GROUP	MODEL
BOD	2025MY EV9 (MVa)
NUMBER	DATE
343	September 2025

## TECHNICAL SERVICE BULLETIN

### SERVICE ACTION: OUTSIDE DOOR HANDLE COVER SCREW REPLACEMENT (SA627)

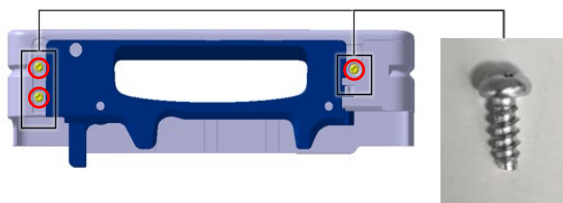
1. Ensure all four (4) door handles are fully retracted (the doors should be in the deployment position).

If needed, adhere a piece of paper to the doors just below the door handle to add protection while working.
